To:	All Bidders
From:	Sandra Lovaas, Measure C Bond Manager Pleasant Valley School District
Subject:	Addendum 3, Bid FB-25-04, Pavement Rehabilitation Project, Dos Caminos Elementary School

Bid FB-25-04, Pavement Rehabilitation Project, Dos Caminos Elementary School Revised Addendum 3

TO:	Pleasant Valley School District
ATTN:	Sandra Lovaas
SUBJECT:	Dos Caminos ES Bid FB-25-04
WORK ORDER:	1002
DATE:	April 1, 2025

ADDENDUM NO. 3

SCALE: HORIZ. <u>1" = 10'</u> VERT. WORK ORDER 1002 DRAWN BY: MEM $T_{\rm JS}$ SHEET NO. 3 OF 10

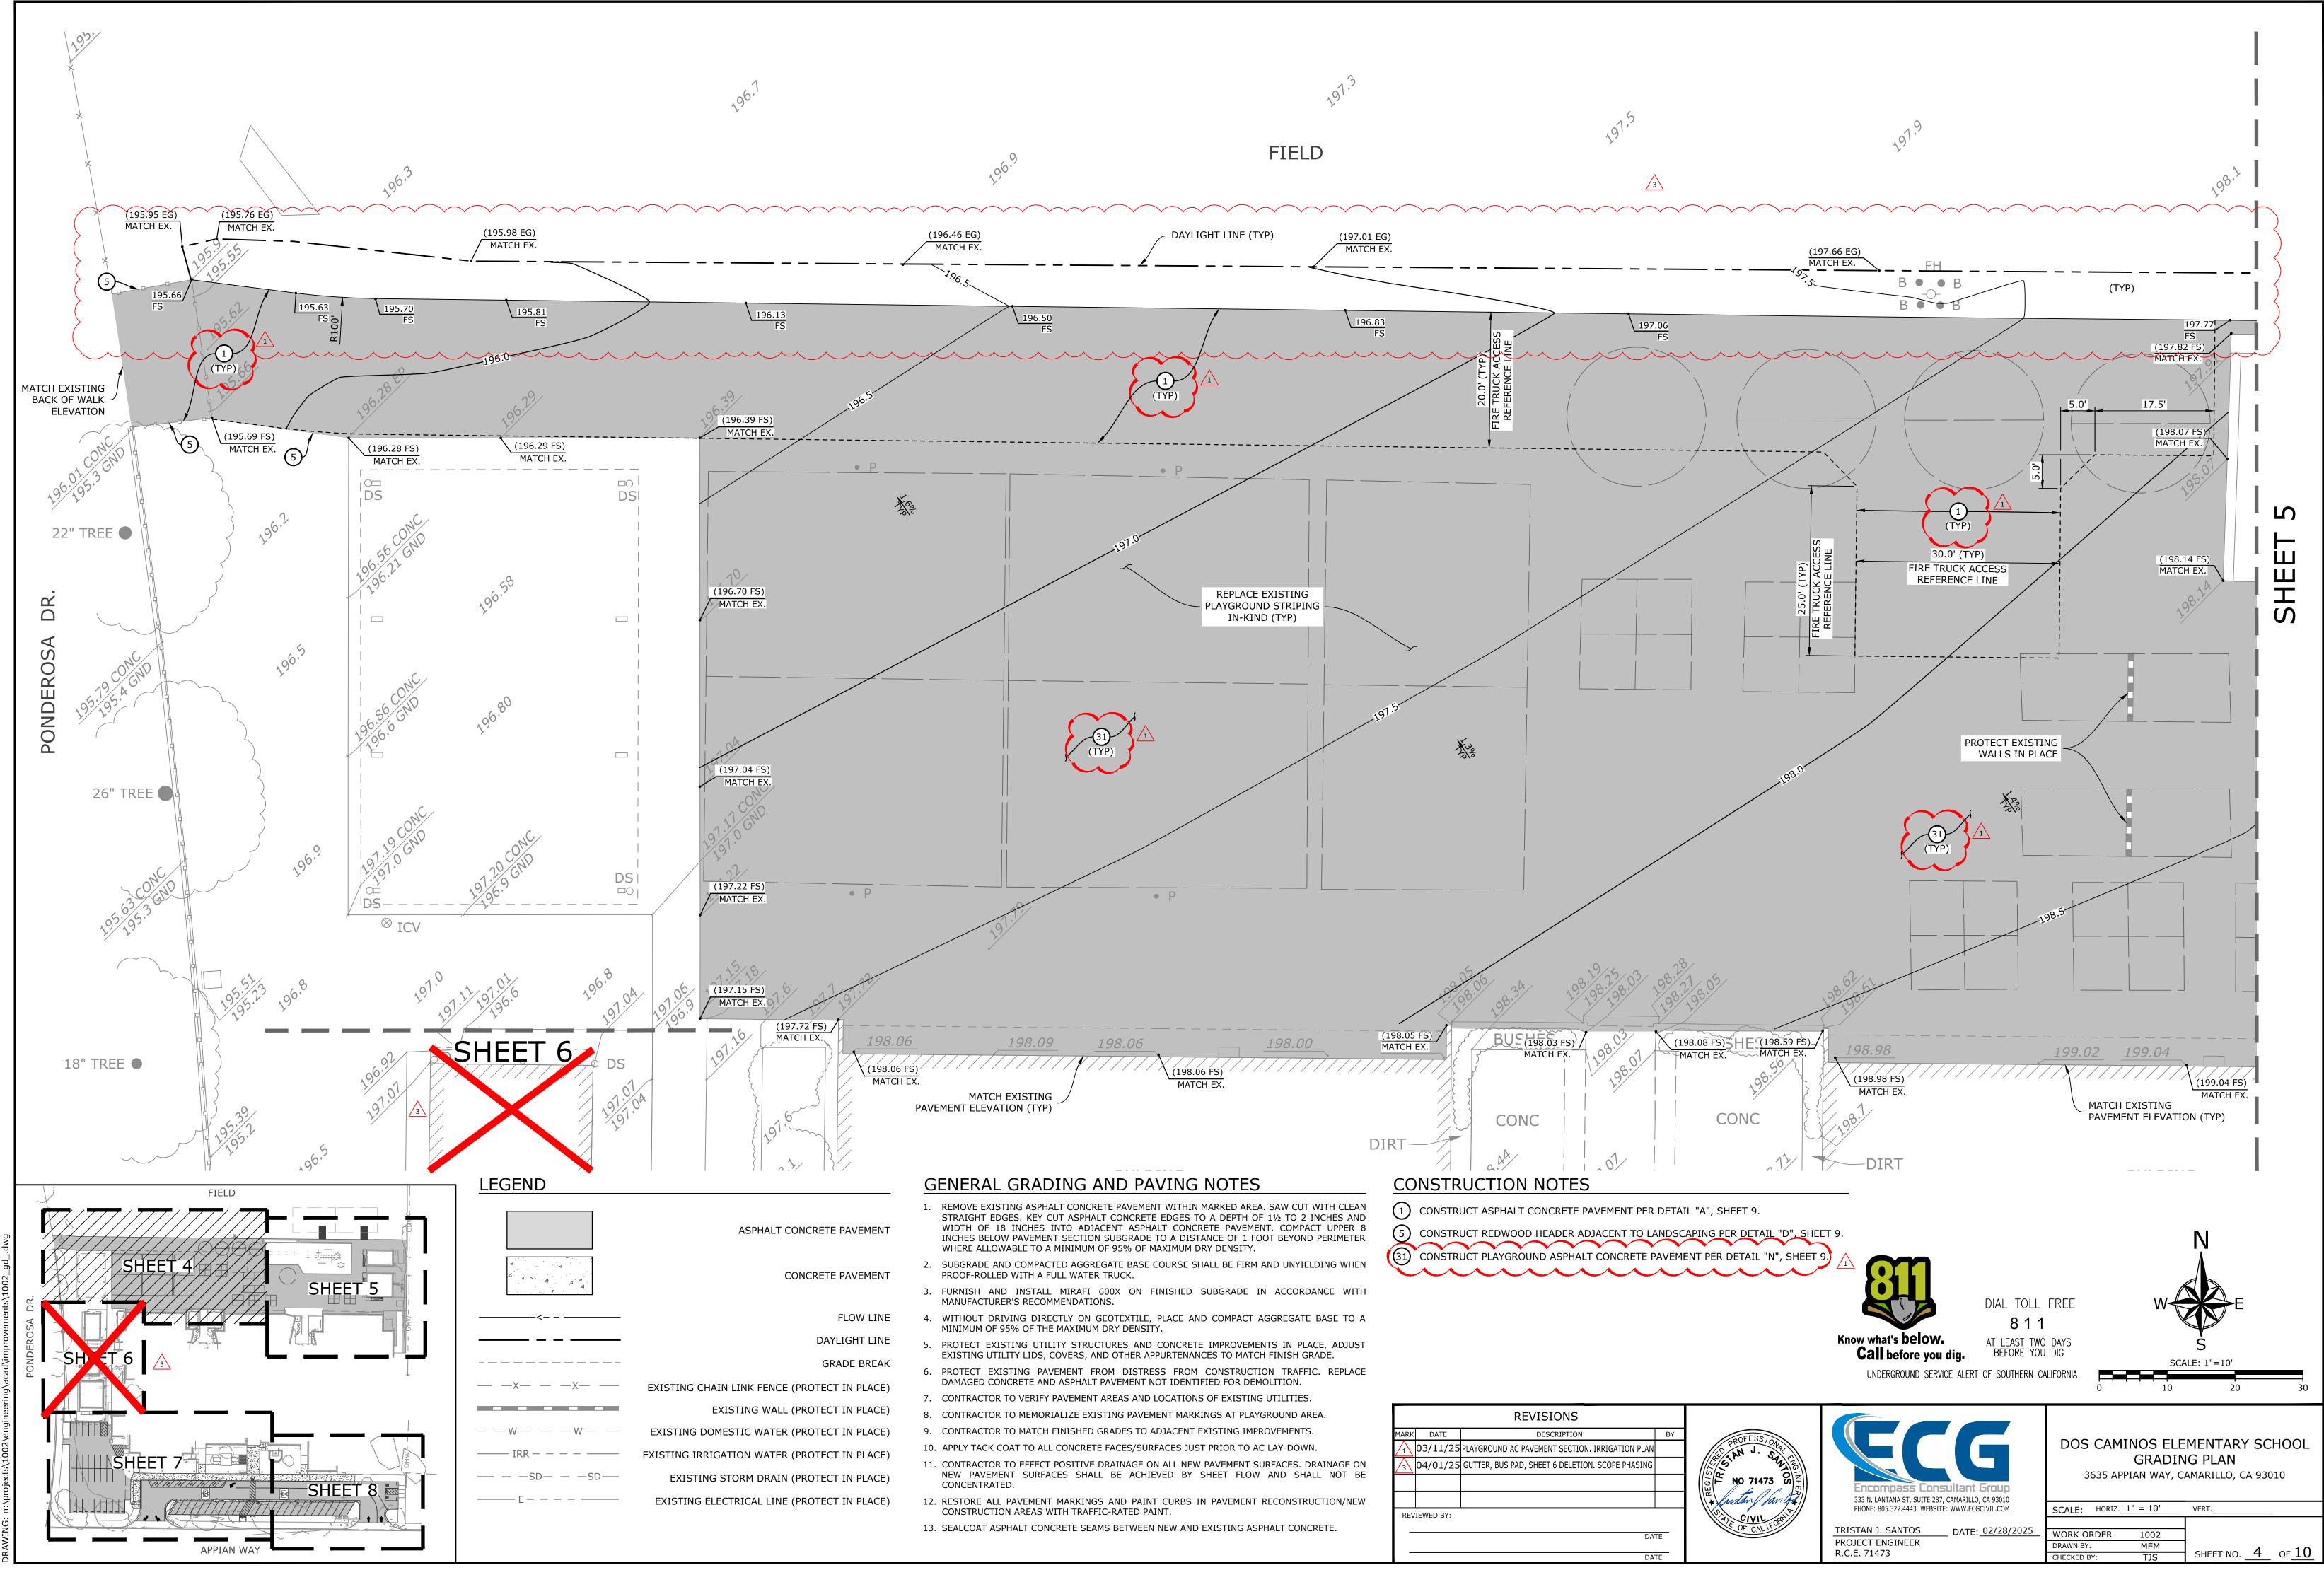
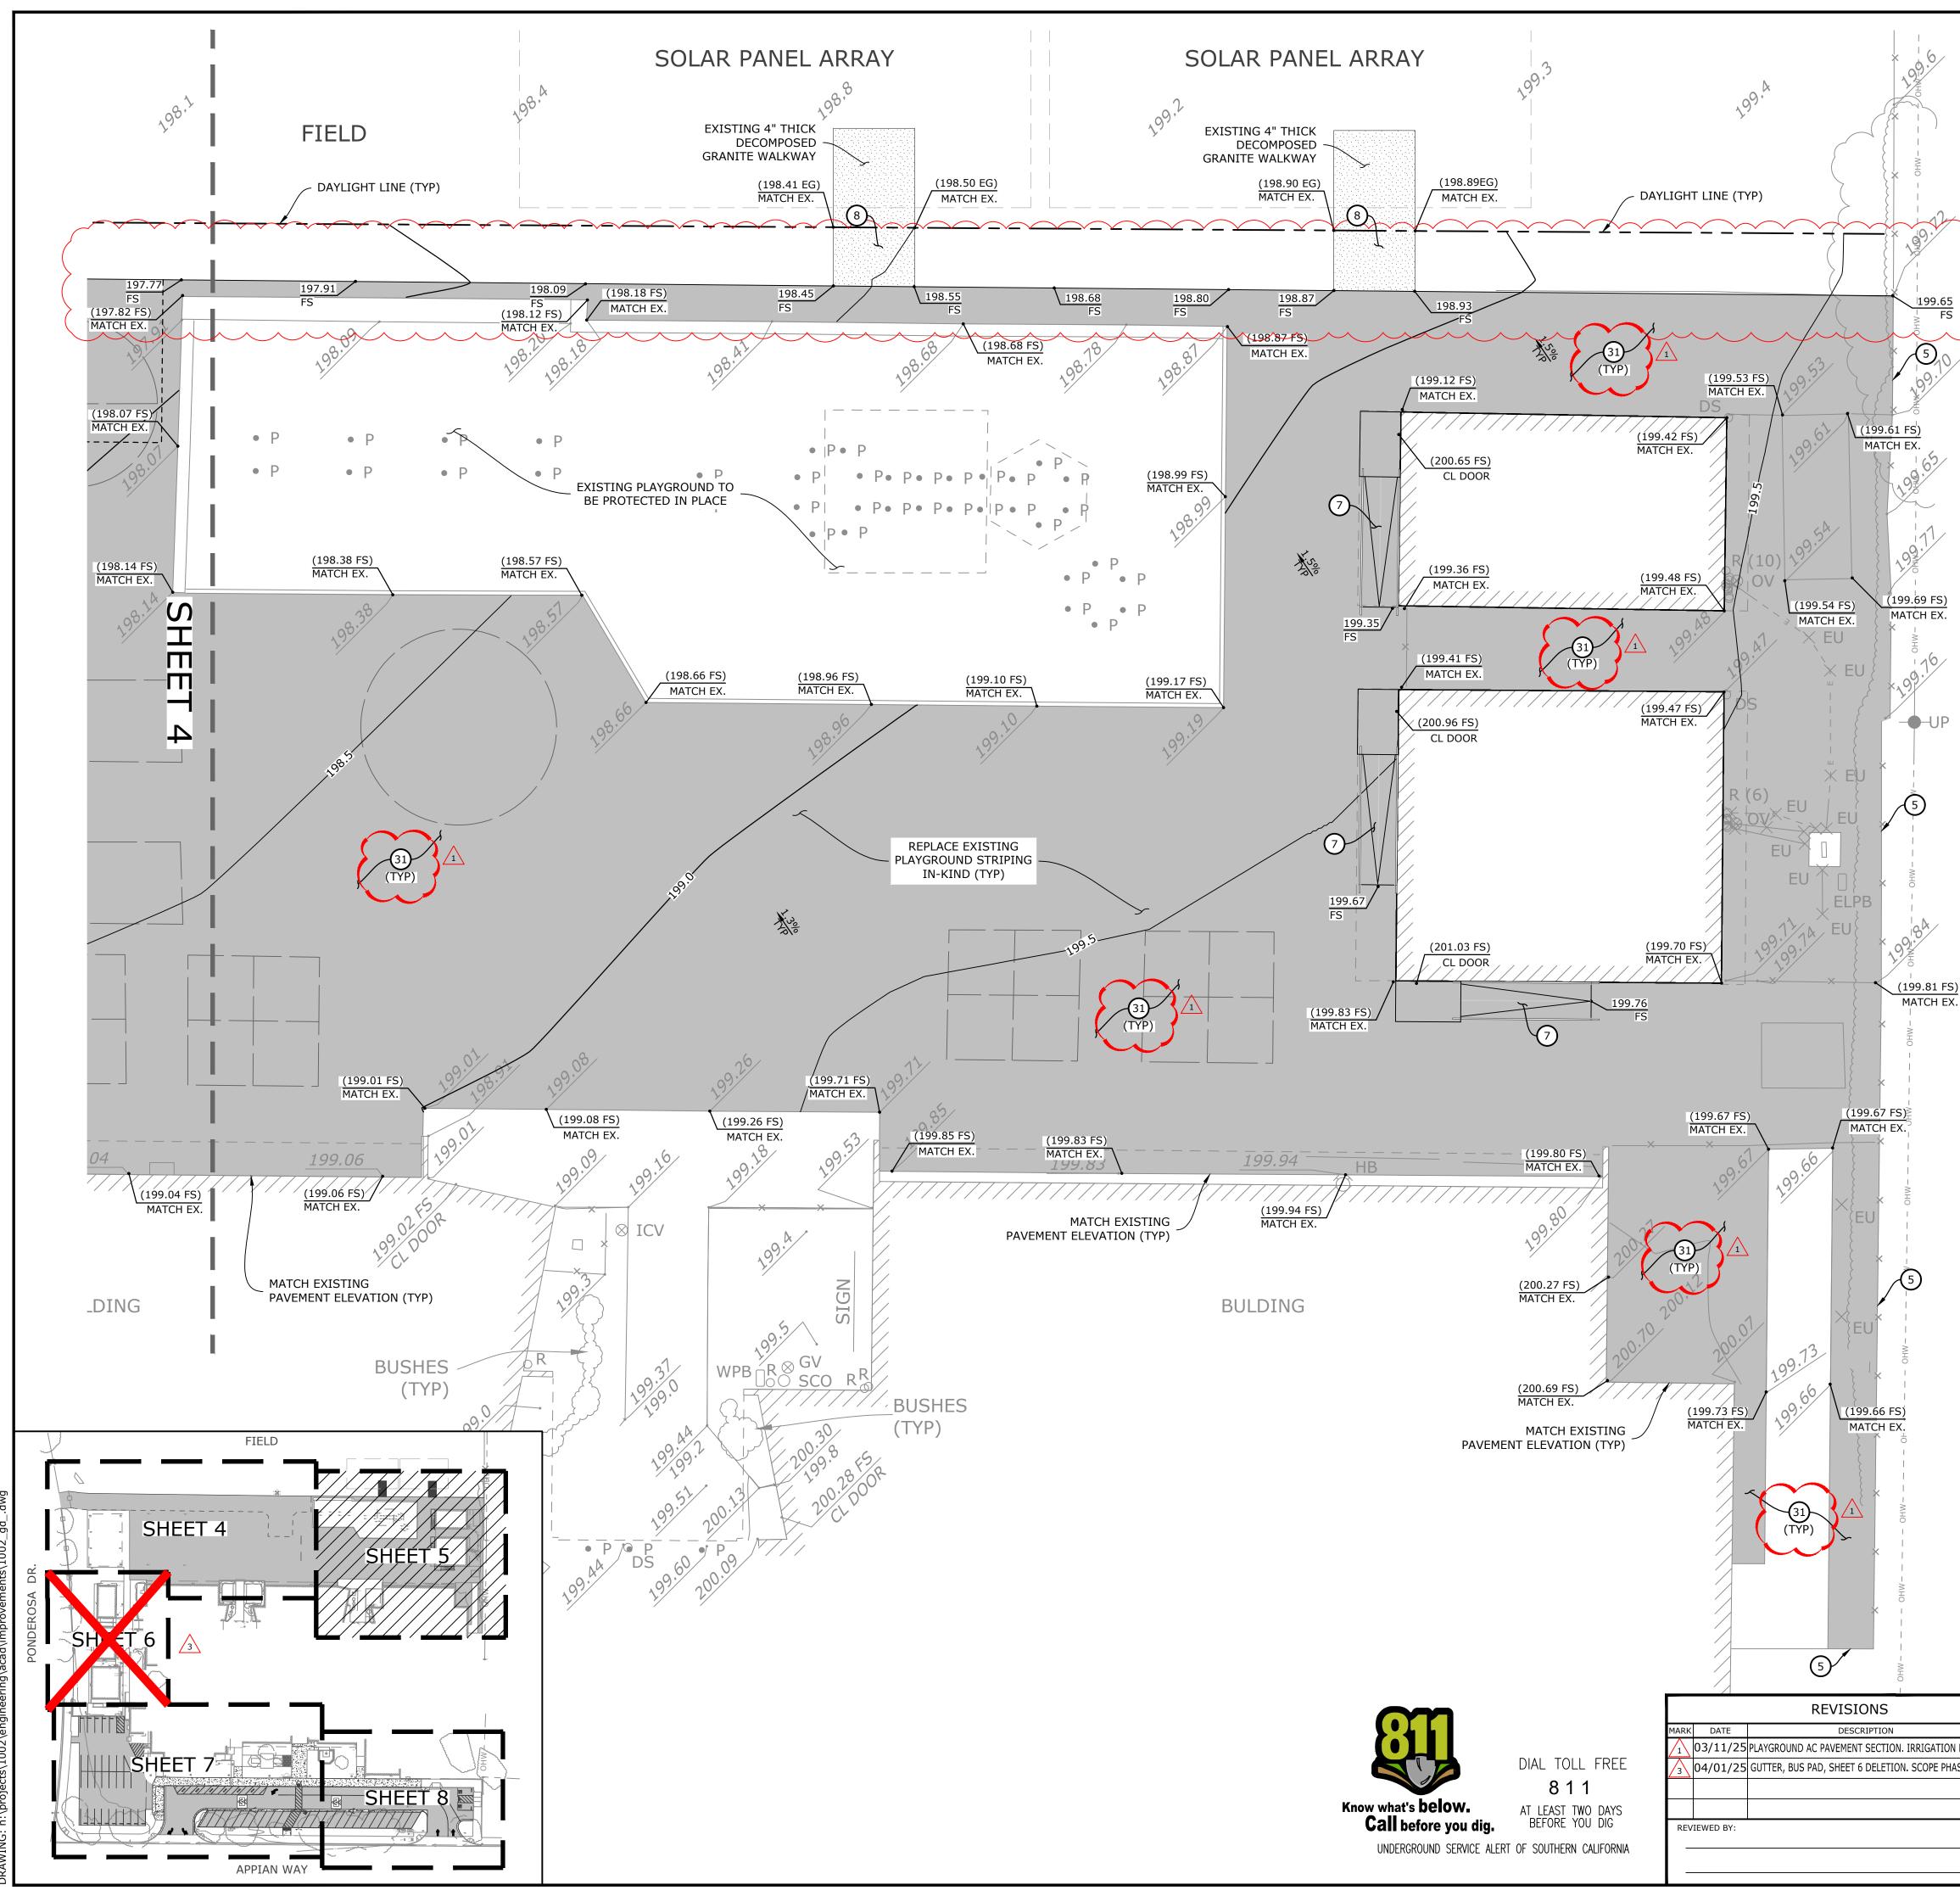
- 1. Demo plan sheet 2 Note 5 calls for relocation of sheds to be coordinated with the district representative. Are the sheds portable and where exactly are they getting moved to.

- Sheds are portable. District representative will determine and coordinate with contractor for location on-site.
- 2. Please confirm there is no over excavation requirement for the sub-grade.
